**PLANNING COMMISSION MEETING
THURSDAY, JUNE 23, 2022**

**DOCUMENTS RECEIVED AFTER
PUBLISHED AGENDA**

**Proposed Development of 314 Rental Apartments, including 19 Units Affordable to Very Low and Low-Income Households, 7,100 Square Feet of Ground Floor Retail Space, and Related Site and Footage Improvements, Requiring Approval of Addendum of a Mitigated Negative Declaration, Major Site Plan Review, Administrative Use Permit, and Density Bonus.
Application No. 202003725
Located at 22330 Main Street**

Public Comment: PH-22-029
Highlighting inconsistency in Arborist
report

Inconsistent /inaccurate map used in Arborist report

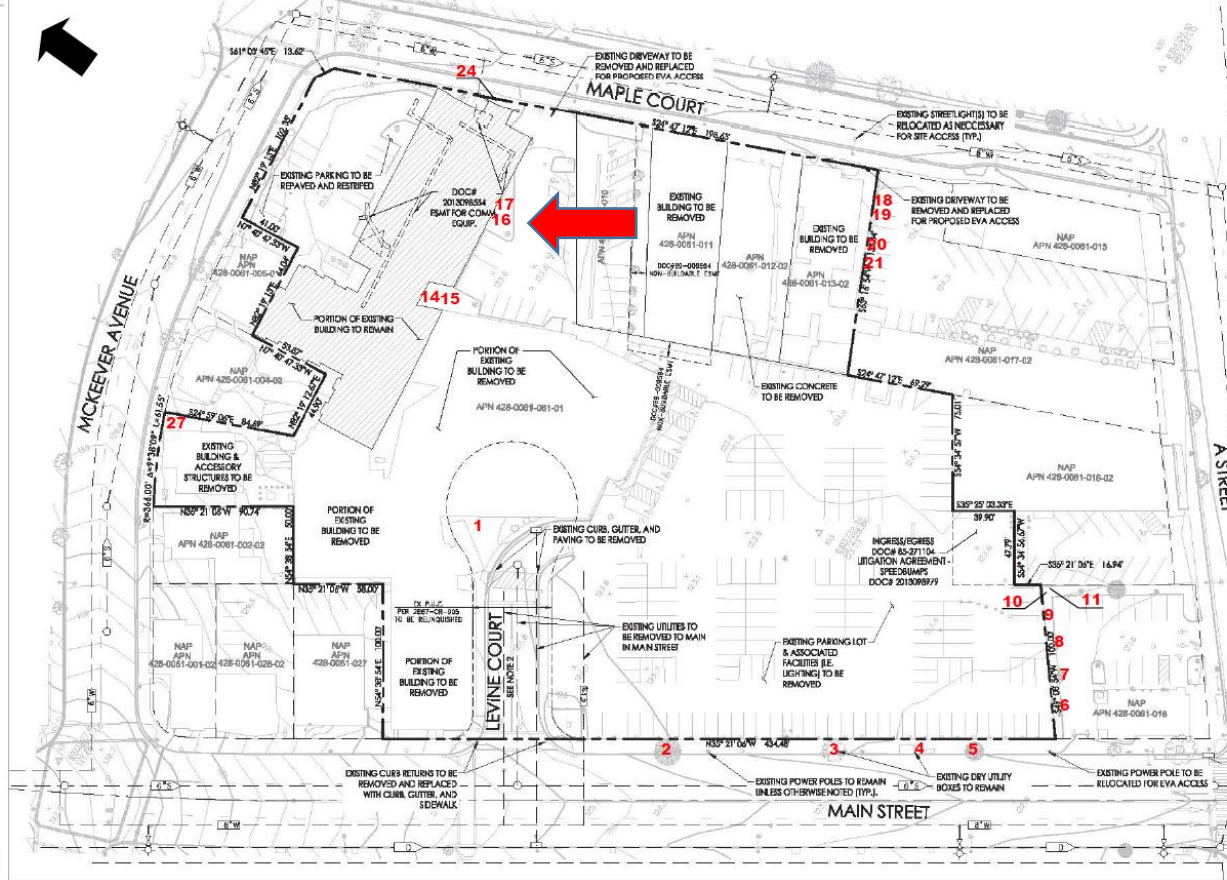
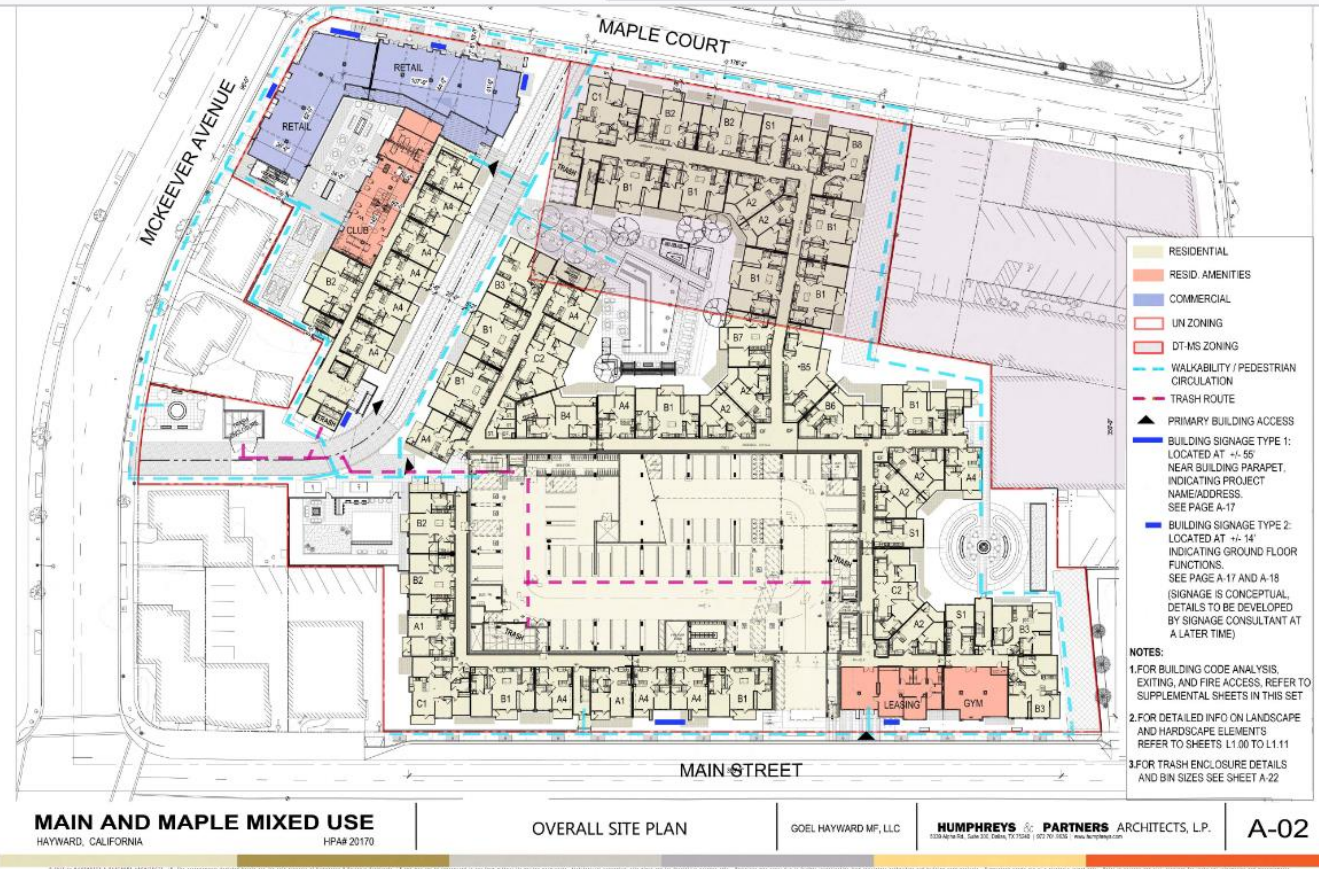
16	Coast redwood	27	Yes	Remove, within new buildings
17	Coast redwood	18,14	Yes	Remove, within new buildings

*** Map used by Arborist report seems obsolete and not to scale**
Arborist report suggests these are within boundary as reason for removal.
But as per actual plan map, Redwood Tree-16, Tree-17 (27" diameter) seem outside the building and can be preserved.

- (1) Developer or City should get additional Arborist report from another independent Arborists which includes:
 - (a) Recalculation of Tree Appraisal value for impacted Trees.
 - (b) Accurate location of trees on final plan map.
 - (c) Pictures of impacted Trees.

(2) Developer should submit at-least two alternate sidewalk design proposals to preserve Chinese Tallow and Redwood Trees 16 and 17
